STAFF REPORT

Case No.: 20-SP-08

Request: Conduct a public hearing and consider the request for a Detailed Site Plan amendment for an attached single-family development on an approximately 0.75-acre lot located at 2620 Valley View Lane, including Special Exceptions; and take appropriate action.

Planning & Zoning Commission Meeting: August 31, 2020

Special Exception #5 – Section I.J.6.

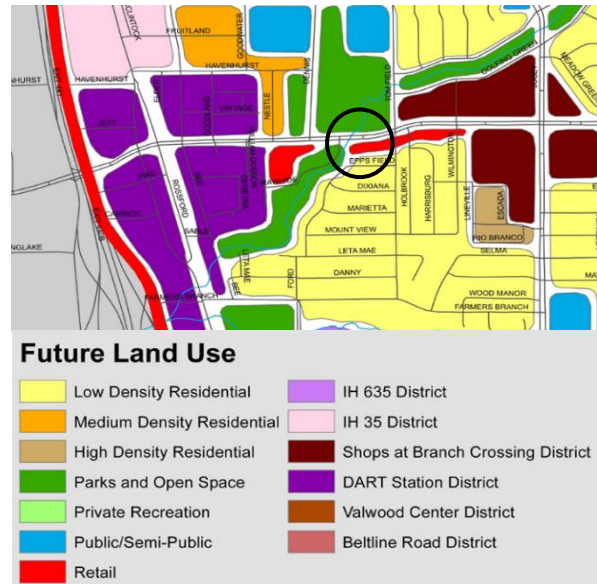
The applicant is seeking approval of a special exception to allow for reduction in the width of the sidewalk to four feet. The applicant has expressed concern that the proposed 4-foot sidewalk would be consistent with the sidewalks along Valley View Lane and would avoid the need to relocate an existing fire hydrant and electrical pole located within the right-of-way.

Staff believes that the requested special exception is not appropriate given that the 4-foot sidewalk is located back-of-curb to Valley View Lane. Valley View Lane is a six-lane divided arterial street that carries high traffic volumes. The proposed sidewalk will connect this development with the existing public park and Station Area to the west. Therefore, the sidewalk should encourage pedestrian traffic and walkability. At the time this property was rezoned in 2008, the Station Area

Code and the city's goals for urban development based on pedestrian and transit-oriented development principles were already in place, hence the requirement for the 8-foot wide sidewalk. The existing fire hydrant and utility pole were known conditions prior to the development of the property.
